AGENDA  
DESIGN COMMISSION  
Community Room, 3rd Floor  
Arlington Heights Village Hall, 33 S. Arlington Heights Rd.  
Arlington Heights, IL 60005  
January 27, 2026  
6:30 PM

**MINUTES OF  
THE VILLAGE OF ARLINGTON HEIGHTS  
DESIGN COMMISSION**

**Department:** Planning & Community Development

**Department:** Planning & Community Development

SHEET TITLE  
 ELEVATIONS

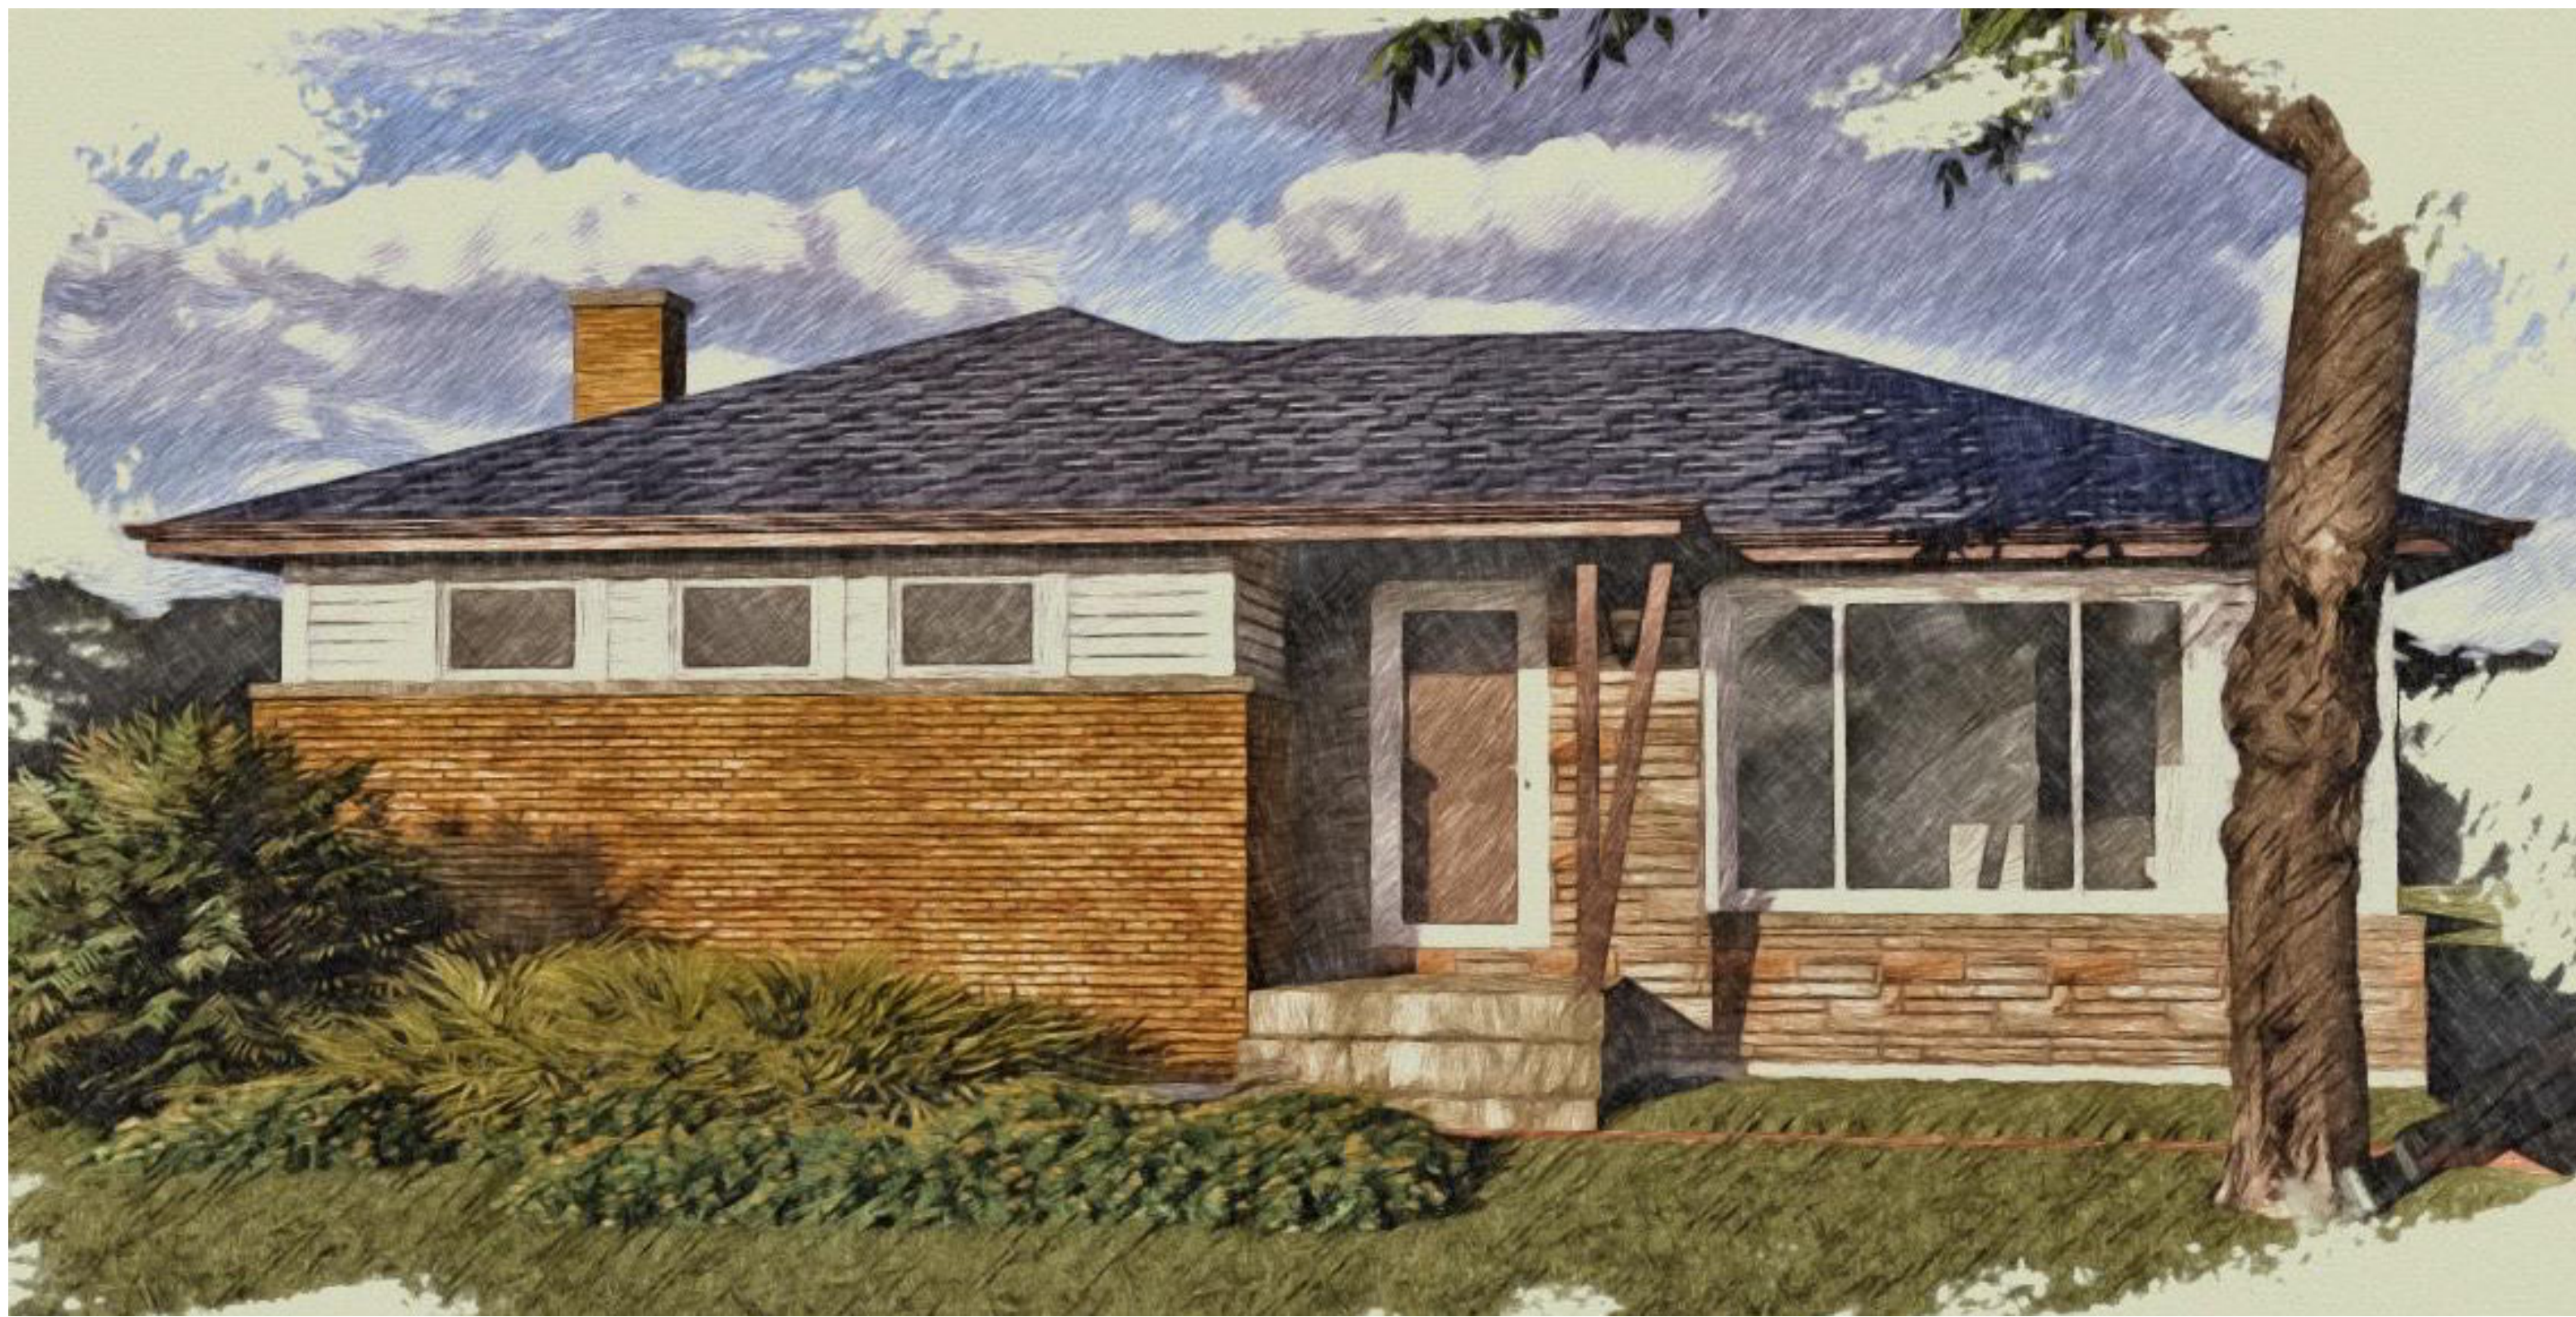
5. A recommendation to add some windows to the north elevation to break up the blank wall.
6. This review deals with architectural design only and should not be construed to be an approval of, or to have any other impact on, any other zoning and/or land use issues or decisions that stem from zoning, building, signage or any other reviews. In addition to the normal technical review, permit drawings will be reviewed for consistency with the Design Commission and any other Commission or Board approval conditions. It is the architect/homeowner/builder's responsibility to comply with the Design Commission approval and ensure that building permit plans comply with all zoning code, building permit and signage requirements.

4. Color Scheme. The proposed black & white color scheme will have a bold appearance in this location. An earth tone color scheme is recommended to better fit with the surrounding context which will soften the appearance.
5. North Elevation. A recommendation to add some windows to the new second story to break up the blank wall.

5. A recommendation to add some windows to the north elevation to break up the blank wall.
6. This review deals with architectural design only and should not be construed to be an approval of, or to have any other impact on, any other zoning and/or land use issues or decisions that stem from zoning, building, signage or any other reviews. In addition to the normal technical review, permit drawings will be reviewed for consistency with the Design Commission and any other Commission or Board approval conditions. It is the architect/homeowner/builder's responsibility to comply with the Design Commission approval and ensure that building permit plans comply with all zoning code, building permit and signage requirements.

**SITE PLAN**  
SCALE: 1" = 20' 0"

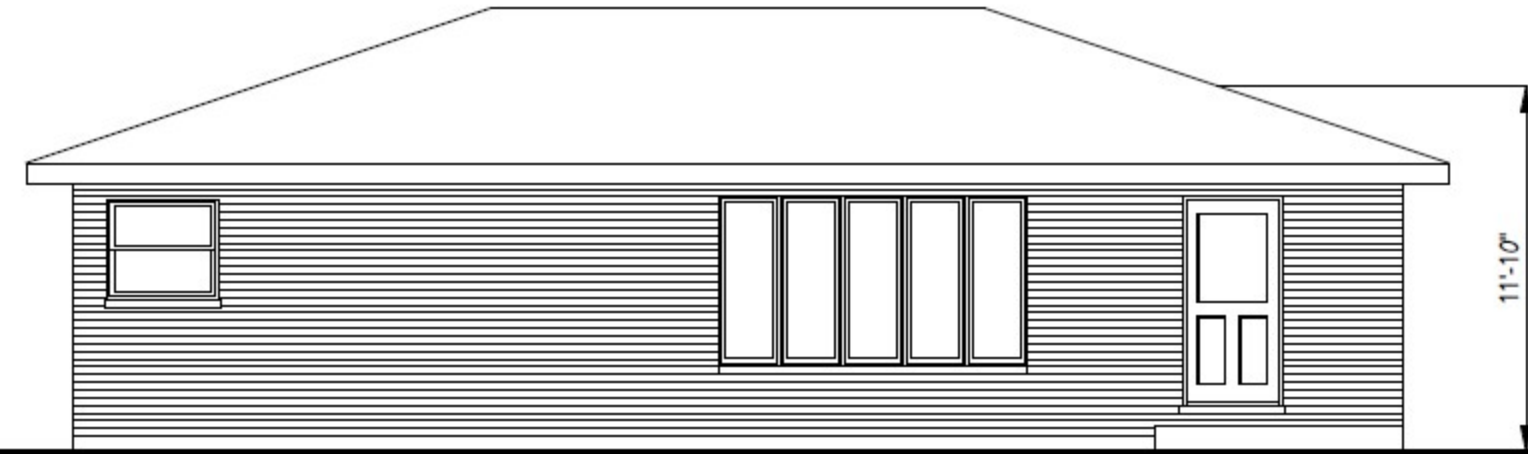
4. Revise the Site Plan to adjust the placement of the house with a 25-foot front setback to align with the other homes on the block, and coordinate the layout of the new driveway to maintain a minimum 8-feet of clearance from the existing parkway tree.

The subject property is located on a street with a mix of single-story, split-level, and two-story houses. The existing homes have a mix of both attached and detached garages. The existing homes on the block are all relatively aligned with an approximate 25-foot front setback. The proposed new house is shown with a 29-foot front setback. It is recommended that the front setback be changed to 25-feet to align with the other homes on the block. Additionally, there is an existing parkway tree that is required to be protected and preserved. The parkway tree needs to be shown on the Site Plan and coordinated with the new driveway to maintain a minimum 8-foot of clearance.

4. Revise the Site Plan to adjust the placement of the house with a 25-foot front setback to align with the other homes on the block, and coordinate the layout of the new driveway to maintain a minimum 8-feet of clearance from the existing parkway tree.

**ROOF DESIGN - AS SUBMITTED**

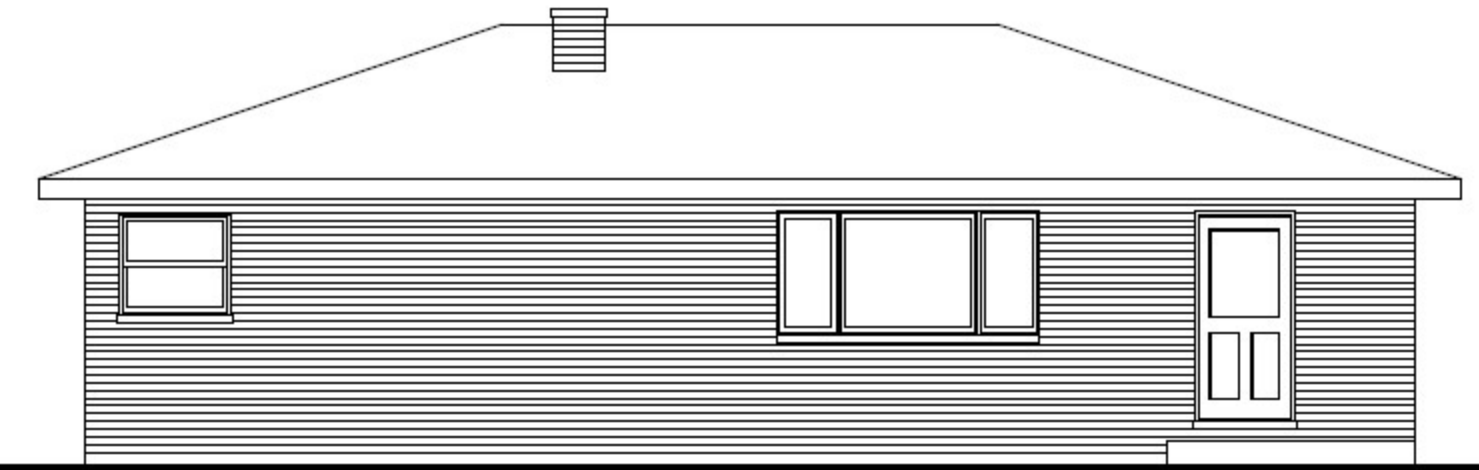
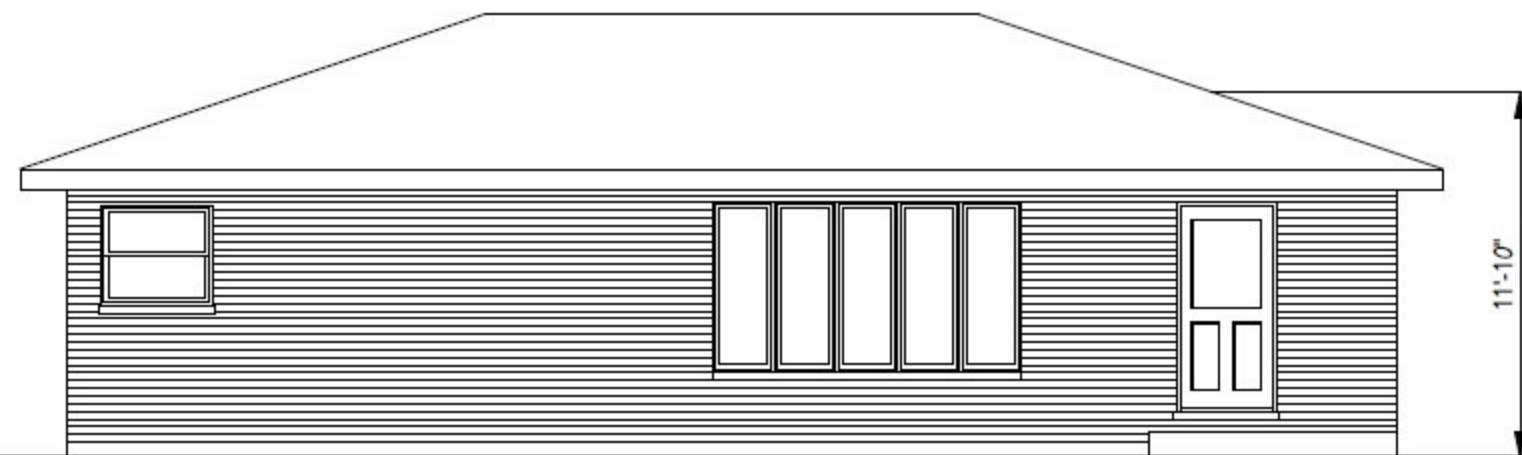
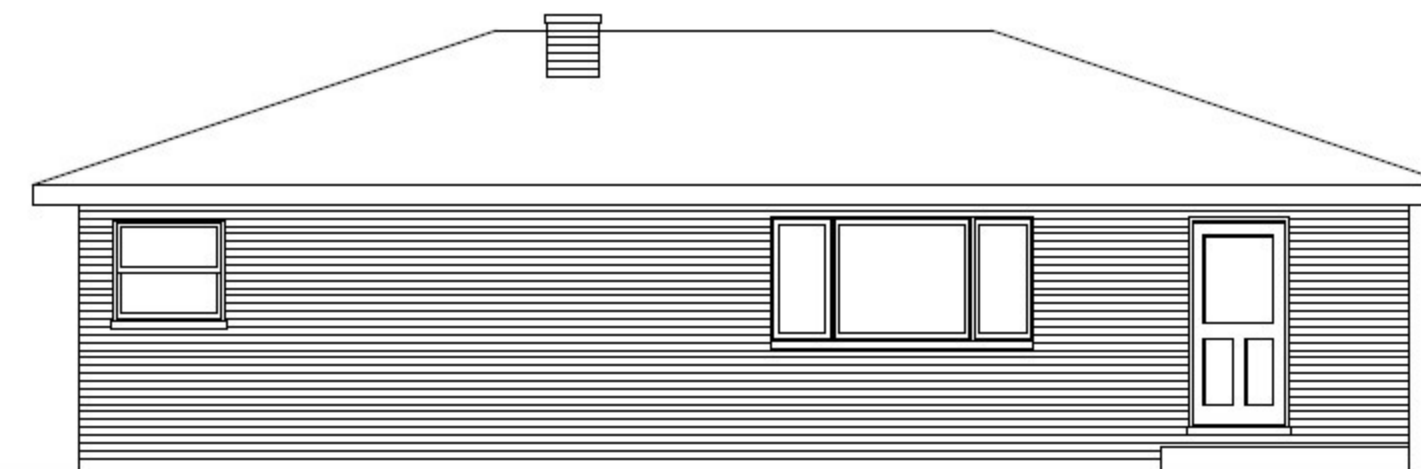
1. Evaluate the scale and character of the proposed new home against the surrounding context which is mostly smaller-scale homes.
2. A recommendation to change the roof design without the steep gables and a hipped main roof to better fit with the adjacent homes.

1. Evaluate the scale and character of the proposed new home against the surrounding context which is mostly smaller scale homes.
2. A recommendation to change the roof design without the steep gables and a hipped main roof to better fit with the adjacent homes

FRONT ELEVATION

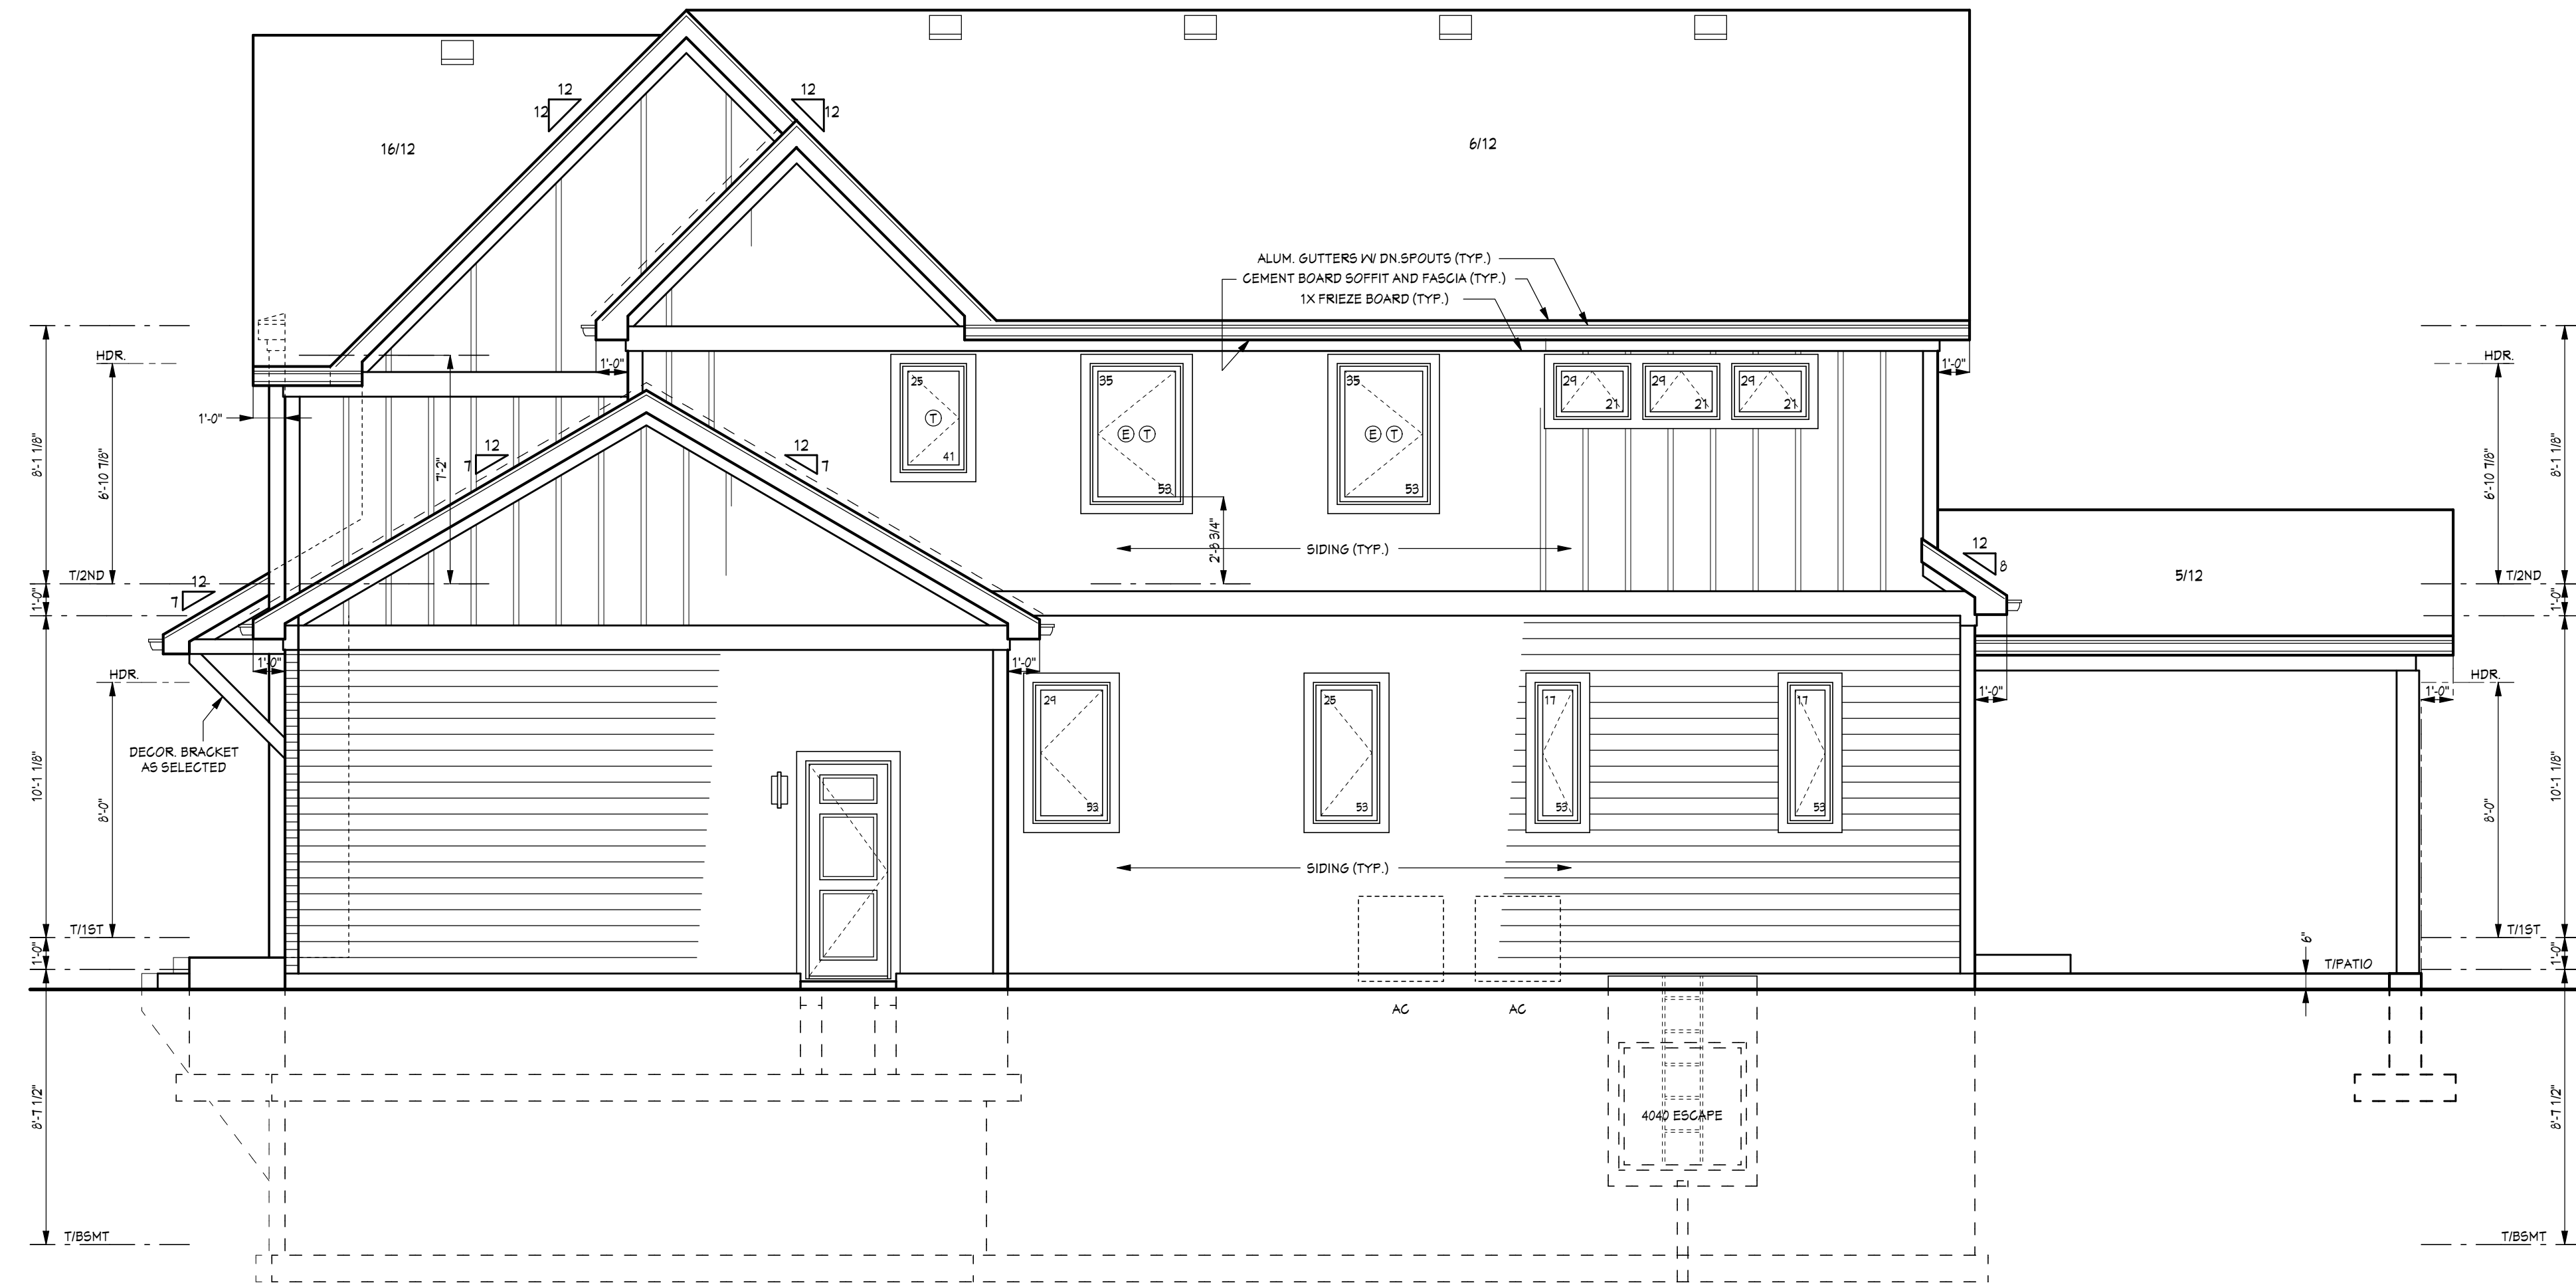
5. Change the garage door to a chevron style door to coordinate with the chevron pattern in the bay windows.
6. This review deals with architectural design only and should not be construed to be an approval of, or to have any other impact on, any other zoning and/or land use issues or decisions that stem from zoning, building, signage or any other reviews. In addition to the normal technical review, permit drawings will be reviewed for consistency with the Design Commission and any other Commission or Board approval conditions. It is

5. Change the garage door to a chevron style door to coordinate with the chevron pattern in the bay windows.
6. This review deals with architectural design only and should not be construed to be an approval of, or to have any other impact on, any other zoning and/or land use issues or decisions that stem from zoning, building, signage or any other reviews. In addition to the normal technical review, permit drawings will be reviewed for consistency with the Design Commission and any other Commission or Board approval conditions. It is the architect/homeowner/builder's responsibility to comply with the Design Commission approval and ensure that building permit plans comply with all zoning code, building permit and signage requirements.
